Land West of Ratby

Pell Frischmann Response to ATE Comments

Project	Land West of Ratby
Document Title or Subject	Pell Frischmann Response to ATE Comments
Document Reference	109003-PEF-ZZ-XX-T.TN-H-000016
Revision Reference	S2_P2
Date	13/02/2026

Your Ref: 24/00914/OUT
Our Ref: ATE/24/01346/OUT
Date: 30 January 2026

Figure 1. Audit Routes - Beaumont via Glenfield

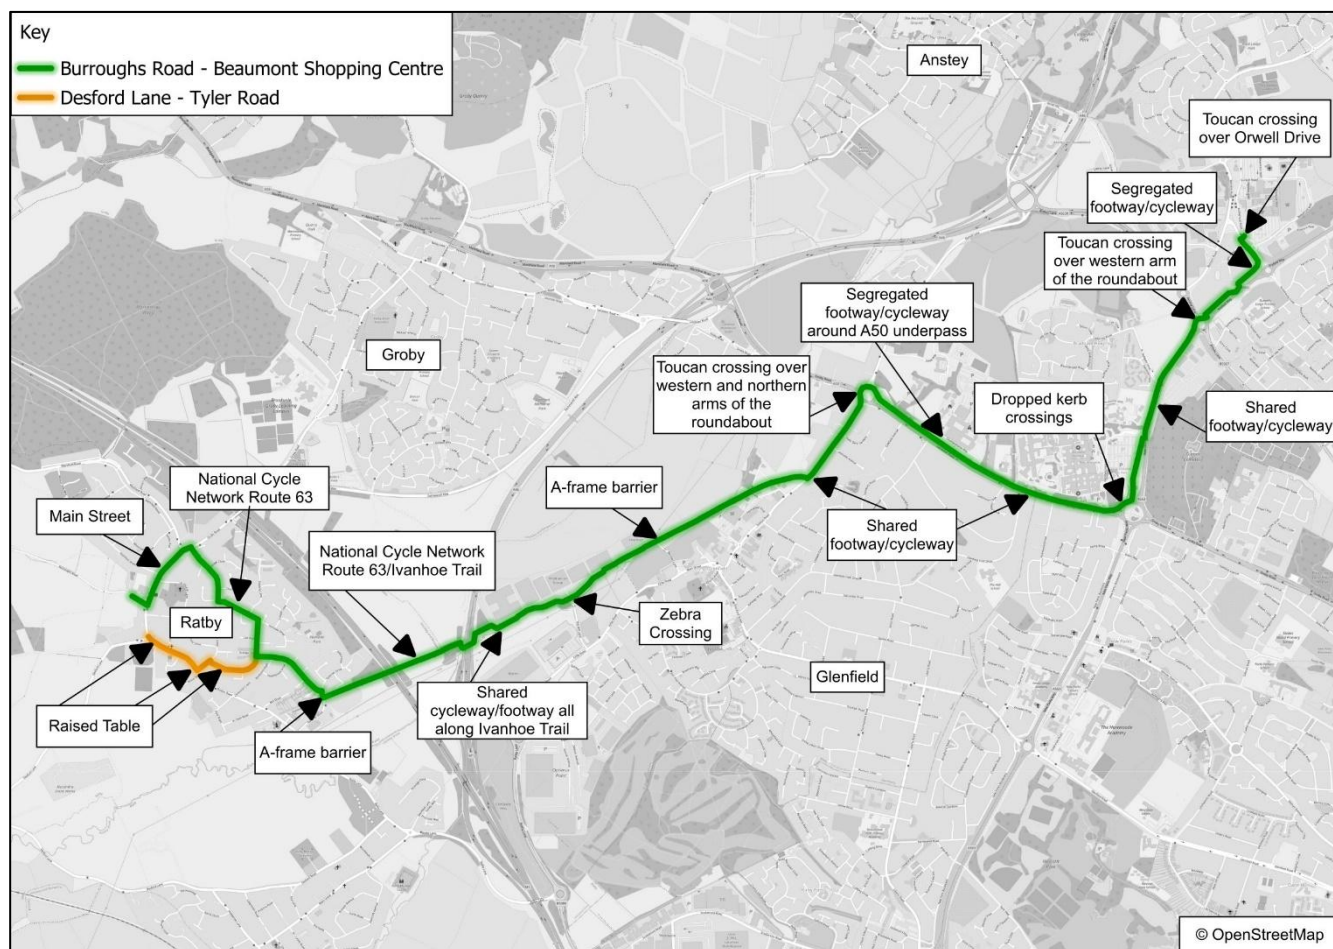
"It is welcome that the Response now reviews the route to the Brookvale Groby Learning Campus using an ATE recognised tool, the Route Check Tool but not the Cycling Level of Service CLoS identified in the induction to this work. The response does not cover the links to Glenfield and Kirby Muxloe and to Timkens employment site, as detailed in the Core Strategy above, however."

- 2.1.1 Pell Frischmann has previously undertaken the route check to the nearest education facilities as requested. ATE have subsequently requested a similar exercise is undertaken for nearby employment facilities. Pell Frischmann have subsequently included a further audit of the route to Glenfield/Optimus point employment area which forms the nearest major employment area. As a robust assessment this route has also been continued to the nearest large retail park, which also passes Glenfield Hospital.
- 2.1.2 The route has been assessed in **Table 1** and shown in **Figure 1**.

#	Policy Principle	Compliance		Commentary
		Existing	Proposed	
P001	Are cyclists separated from pedestrians?	Cyclists travel along shared and segregated footway / cycleways from the Ivanhoe Trail. This is for the majority of the route, approximately 80% of the route.	-	Proposed demand is less than 300 hourly pedestrian / cyclist movements as per the threshold within LTN 1/20. Pedestrians/cyclist demand is low and visibility is high between users due to the long straight providing good lines of view. The shared and segregated facilities that allow for reduced interaction / conflict between users.
P002	Is the route free from barriers such as chicane barriers, steps or dismount signs?	There are barriers / bollards along the Ivanhoe Trail where it intersects with the carriageway, including an A-frame barrier at the start of the trail. There are guardrails around the arms of the key junctions along the A50 and A563.	-	The A-frame barrier means that part of the route cannot easily / continuously traversed. The bollards along the Ivanhoe Trail may make passage difficult if encountering a user heading in the opposite direction, as someone may have to 'give and take'. The guardrails do not affect the flow of the route. They protect the cyclists from the navigating the junctions at the A-roads.

P003	Does the route feel direct, logical and intuitive to understand for all road users?	The route feels generally direct due to their straight paths with limited junctions, especially along the Ivanhoe Trail as well as the shared / segregated facilities. The route is also logical to understand, which is helped by National Cycle Route signs and cycle infrastructure markings.	-	The signage and markings are present throughout the entire route, including through the residential roads of Ratby. Anymore signage / markings may be overbearing to the user and clutter the route. The as the route is the shortest distance it can be, so the flow feels logical.
P004	Are surfaces suitable for all users?	Whilst slowing down the speed of vehicles, there are several raised tables and speed cushion along Main Street in Ratby, which may not be suitable for all users.	-	These traffic calming measures create a safer environment for cyclists throughout Ratby, by reducing they vehicle speeds, meaning cyclists can navigate the carriageway better. This also may encourage more cyclists.

P005	Is appropriate lighting provided?	Appropriate lighting is provided along the entire route, except for the Ivanhoe Trail.	-	Street lighting is provided to ensure year-round usage in Ratby and Glenfield, especially by the A-roads where the visibility is most important.
P006	Does the route join together, or join other facilities together, as part of a holistic, connected network?	The majority of the route is along National Cycle Network (NCN) Route 63, connecting the centre of the site to Ratby and Glenfield. Local cycle routes / infrastructure route north into Beaumont from NCN 63 to pr	-	Local cycle routes / infrastructure route north into Beaumont from NCN 63 to make up a wider connected network

2.1.3 It should be noted that to access this route, users will utilise the new LTN1/20 spine route through the site which forms part of the improvement schemes proposed. Furthermore, as detailed later within this TN, as part of the detailed design process including subsequent quality audit, should further improvements be required to Burroughs Road these will be made as required.

2.1.4 Note that Timkens is located outside of the urban extents as an isolated rural site and therefore, active travel demand will be limited and significant improvements would not be viable to fit demand on this route. Furthermore, the Desford Lane Gladman site which was approved on appeal is located closer to that site and has also not proposed any improvements in the direction of Timkens, likely for this reason. Facilities within Kirby Muxloe are also limited with most of these replicated in central Ratby and so active travel demand here will also be low.

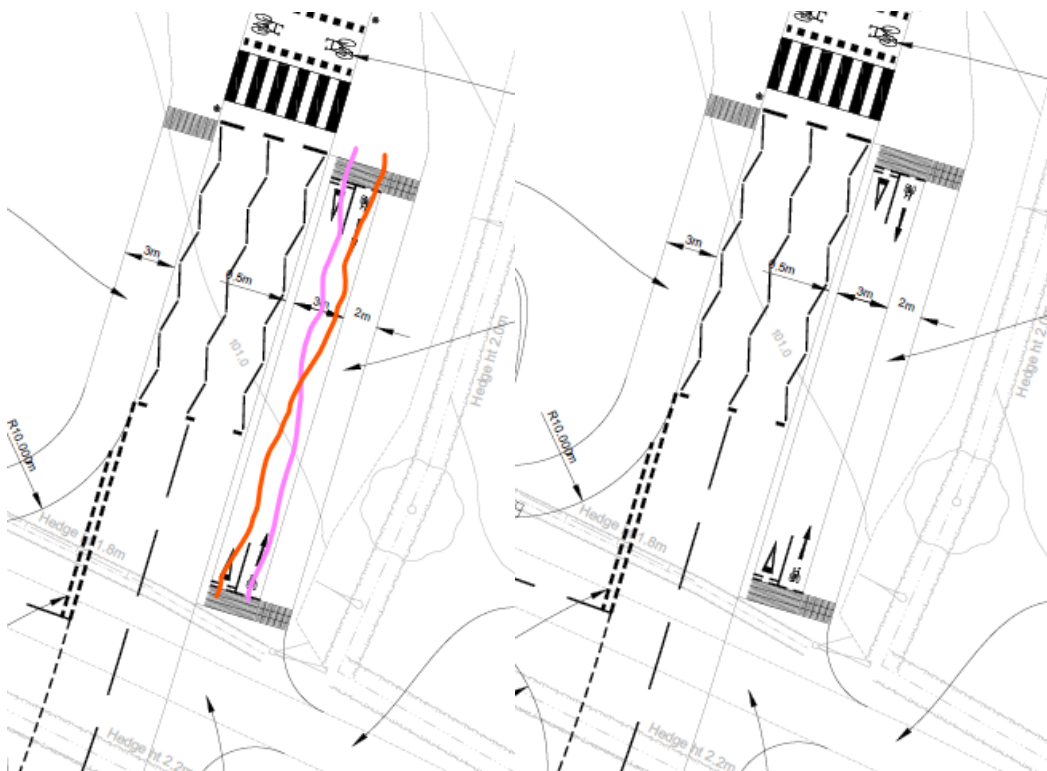
The application has well demonstrated the attractiveness of Burroughs Road to education and local facilities and it will be likely to support a high number of users given it will be mostly closed to traffic. Vehicles will use to eastern section to access the Plough Inn car park presumably which may have the potential to cause conflict in the narrow section by the substation.

The design for the internal access road junction with Burroughs road drawing 109003 PEF ZZ XX DR TP 00002 is limited in how it will control traffic and would be greatly enhanced by urban design considerations that could effectively come at reserved matters stage or via a design code, however it remains undetermined yet how it fully will interface with the infrastructure at the spine road and at the Plough Inn with vehicles.

- 2.7.1 As previously noted in earlier comments, it is agreed that sufficient detail needs to be shown to demonstrate that the site/scheme is deliverable. The drawings submitted demonstrate the principle of access is appropriate and deliverable which is sufficient for the planning permission being sought. Final designs will be submitted as part of the detailed design phase which the local highway authority has agreed to who will be responsible for adopting the infrastructure.
